**Public Hearing for Final PUD Site Plan – Cutchall
Property Management, LLC**

RECOMMENDATION REPORT

CASE NUMBER: 2016-PUD-03

RE: PUD Site Plan - Initial Review
Lot 10, Southport East Replat Six - Sonic

C1.1

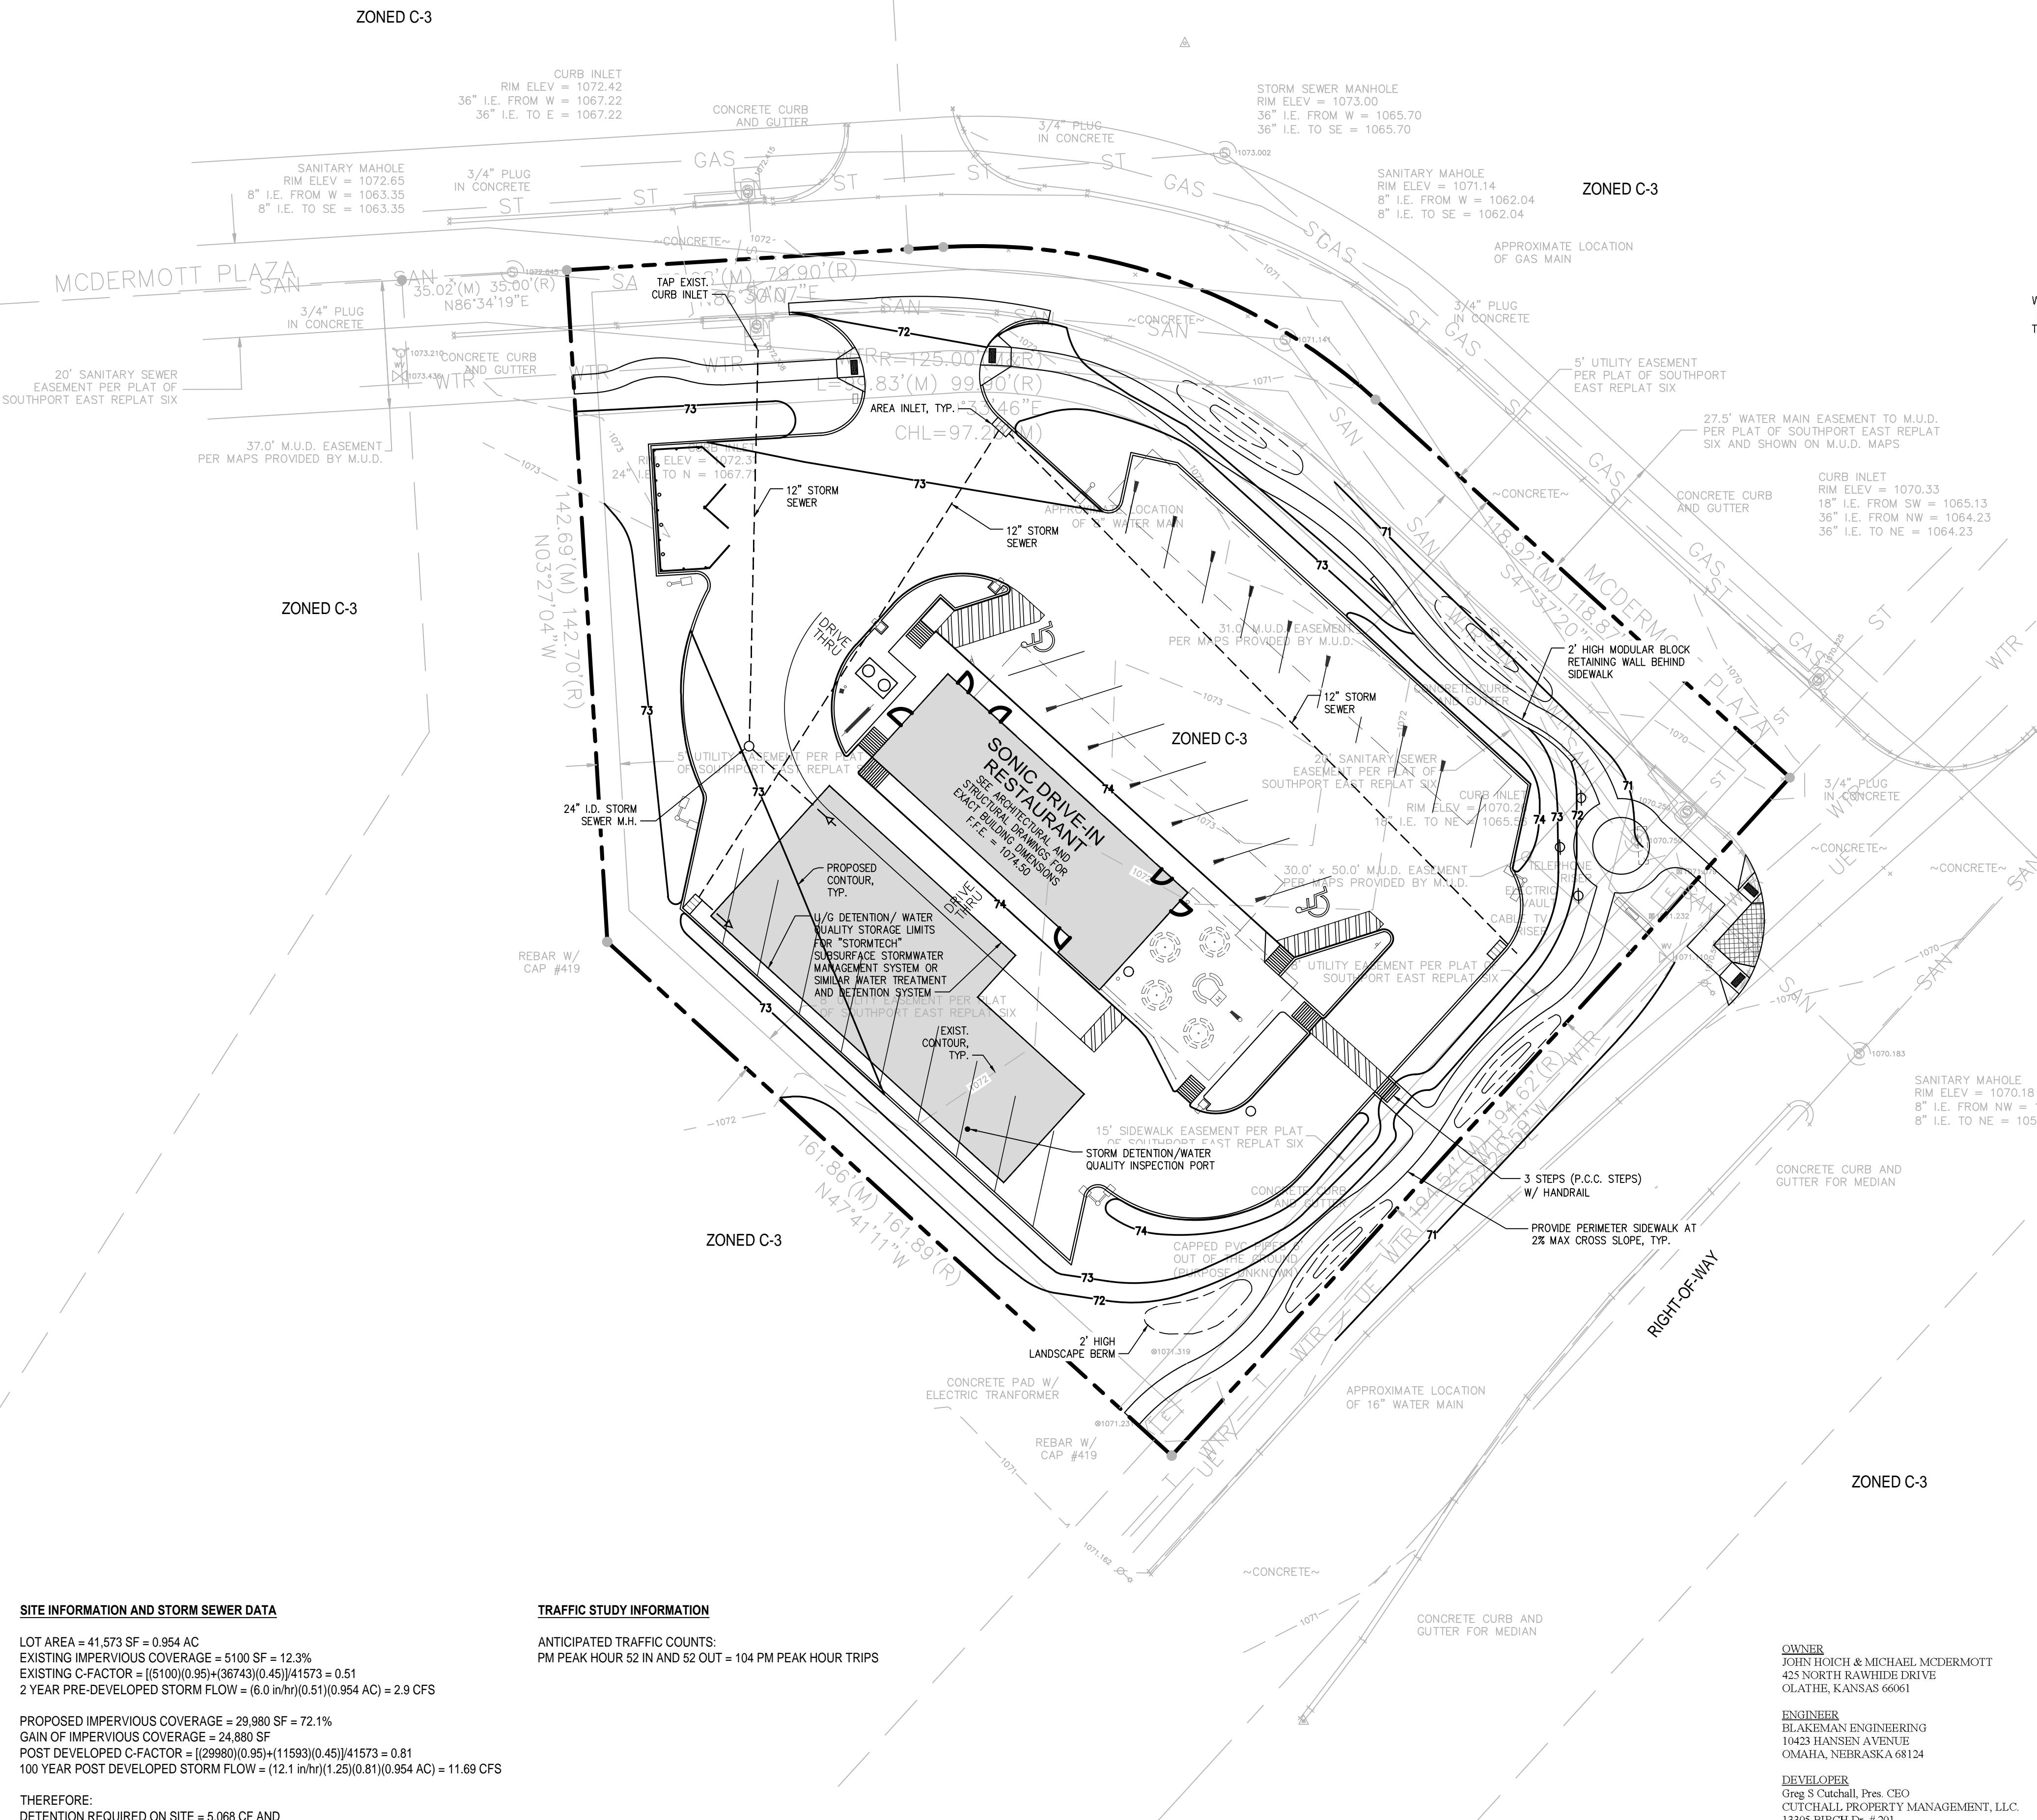
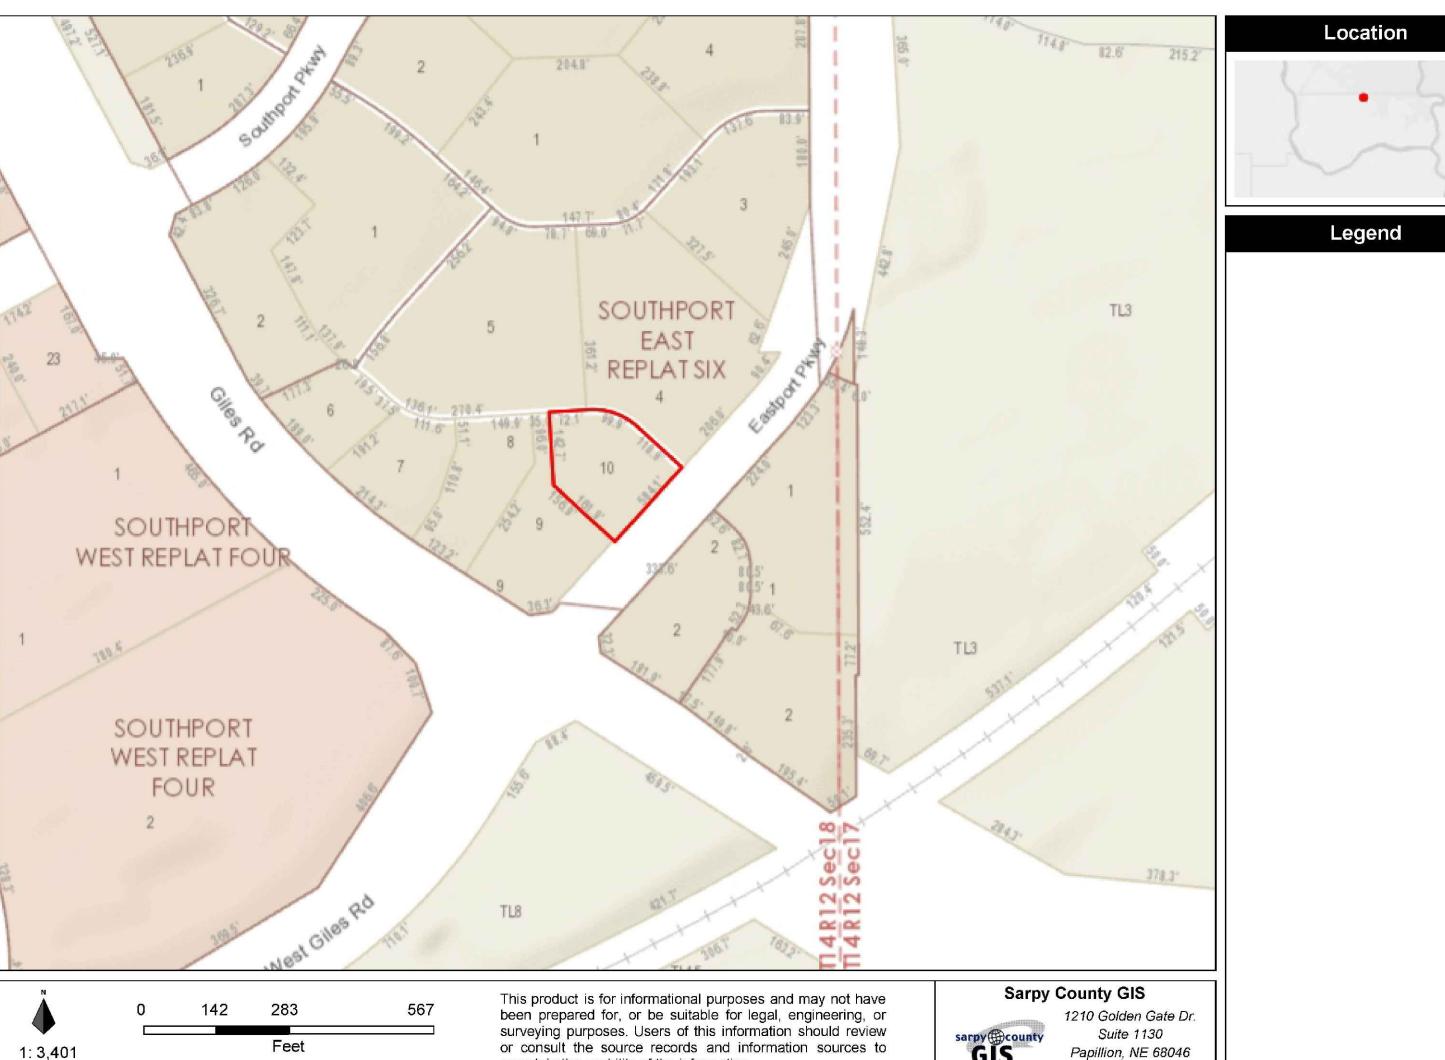
3. In regards to Article 5.15.05.02.1, the proposed 74 contour is missing and is needed to help identify the proposed drainage pattern.
4. In regards to Article 5.15.05.04, there needs to be some notation on C1.1 as to the type of storm water quality and detention system that is proposed. The notes on this sheet about storm sewer data also need to include the proposed 2-year peak flow in post-developed conditions. At this stage it would be acceptable to state that the flow will be limited to the pre-developed condition value if the detention system has not been fully designed yet.

1. Per traffic studies done at several Sonic of similar size and nature traffic counts are anticipated as follows: 24 total AM peak hour (12 in and 12 out), 112 MD peak hour (56 in and 56 out), 104 PM peak hour (52 in and 52 out) trips.
2. Sonic will provide additional sidewalk easement to accommodate sidewalk at intersection of McDermott Plaza and Eastport Parkway. A note has been added to drawings regarding this and final limits of easement area to be determined at time of Construction Drawing review stage.
3. The 74 contour is on the curb all around the building and on retaining wall. Added a "74" on curb for clarity and wall was deleted.
4. Added notes regarding type of storm sewer detention and quality system planned and added note about post construction flows proposed. (Pre-2year condition maintained)
5. Revised to 20'.

C2.1

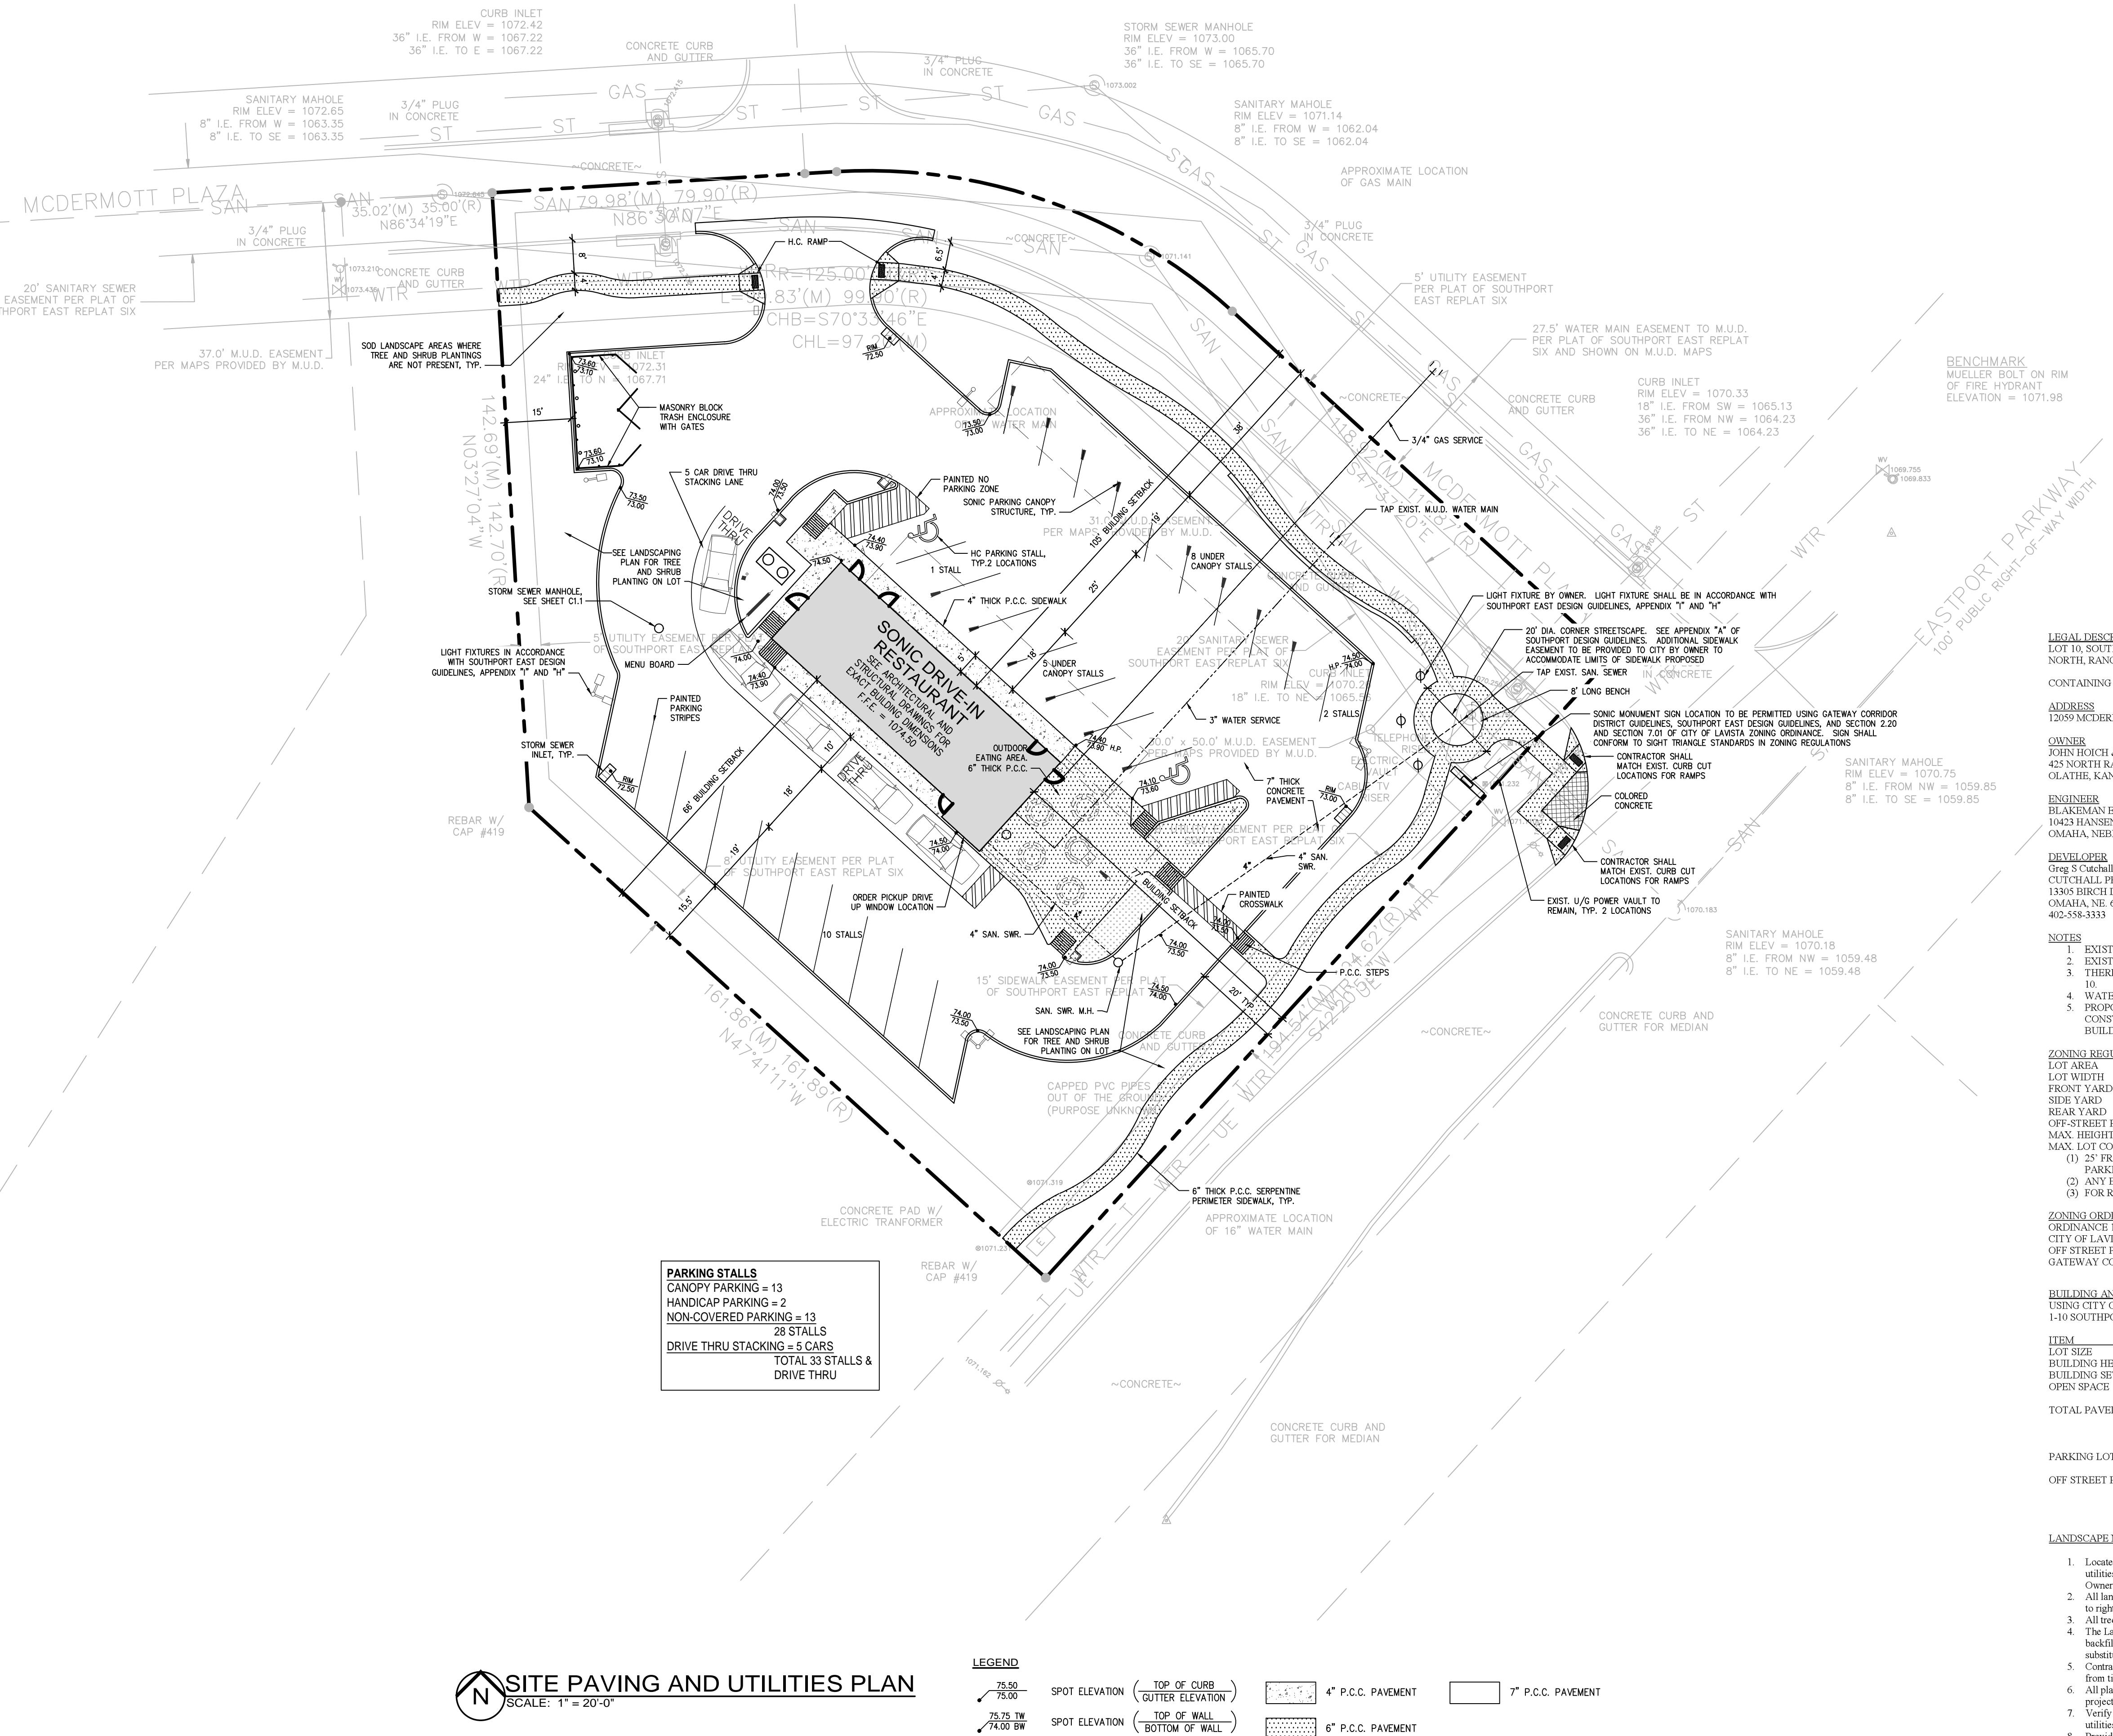
1. Site Grading and Storm Sewer Plan C1.1, Site Paving and Utilities Plan C2.1, and Landscape Plan C3.1:
 - a. Sheet C2.1 appears to demonstrate the perimeter green space required at both the public street frontages, but dimensions aren't provided. Please provide a fully dimensioned plan at the next submittal.

- b. Sheet C2.1 refers to a masonry block trash enclosure with gates. The Guidelines specify a required Trash Screen design (refer to Appendix R). Please submit design details at next review.

- c. Segmental retaining walls indicated will be required to match the color and quality of the base of the building.
 - d. The Guidelines specify specific Exterior Pole Mounted Luminaires and colors (refer to Appendix H & I). Parking lot lighting locations are shown and noted on Sheet C2.1, but not clearly scheduled or demonstrated. It is assumed all lighting will comply with the Guidelines and product data sheets will be submitted at the next review.

1. Site Grading and Storm Sewer Plan C1.1, Site Paving and Utilities Plan C2.1, and Landscape Plan C3.1:
 - a. Sheet C2.1, dimensions have been added to satisfactorily demonstrate the perimeter green space required at both of the public street frontages.

- b. Sheet C2.1 refers to a "MASONRY BLOCK TRASH ENCLOSURE WITH GATES IN ACCORDANCE WITH CITY GUIDELINES". This is acceptable as this stage of review and will be reviewed in detail during the Design Review. The Guidelines specify a required Trash Screen design (refer to Appendix R).

- d. Sheet C2.1, notes have been expanded regarding parking lot lighting locations to represent they will be "...IN ACCORDANCE WITH THE SOUTHPORT EAST DESIGN GUIDELINES, APPENDIX I & H". This is acceptable at this stage of review and product data sheets will be reviewed during the Design Review.

- f. Sheet C2.1, notes have been expanded regarding Site Furnishings required at the circular corner streetscape to represent they will be "...IN ACCORDANCE WITH APPENDIX P OF THE SOUTHPORT EAST
